Austen Quarry Stage 2 Extension Project (MOD 1 - SSD 6084)

Response to Submissions

June 2018

Figure 2: Austroads Turn Treatment Warrants

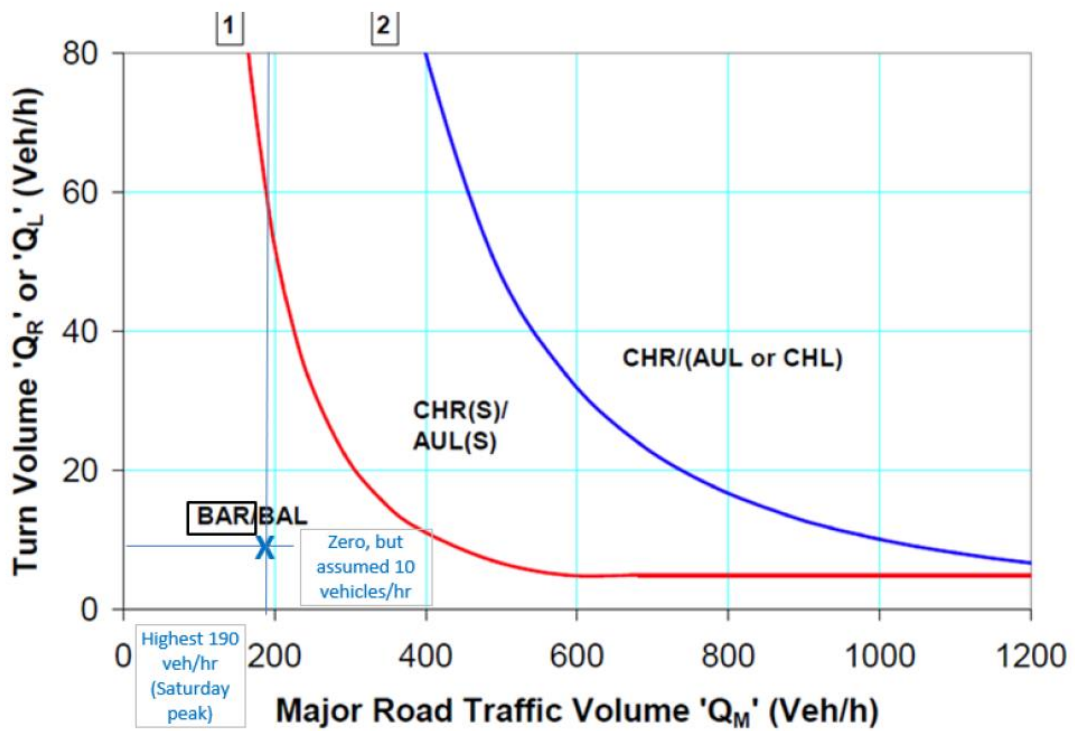
The TTPP correspondence in **Appendix 6** provides a review of the Austroads turn treatment warrants and assesses requirements based on predicted traffic on Jenolan Caves Road in 2035, assuming a nominal value of 10 Quarry-related vehicles turning right per hour. The existing right turn treatment is more than sufficient for this intersection and an upgrade to the CHR(S) should only be necessary should traffic volumes increase to approximately 60 vehicles per hour (see Figure 2 of **Appendix 6**).

Figure 2 indicates that the projected traffic volumes would warrant a BAR treatment, but the subject intersection already provides a higher-order turn treatment with an Auxiliary Right Turn (AUR) treatment. The AUR layout provides a 120m long auxiliary northbound lane enabling traffic to bypass a vehicle waiting to turn right.
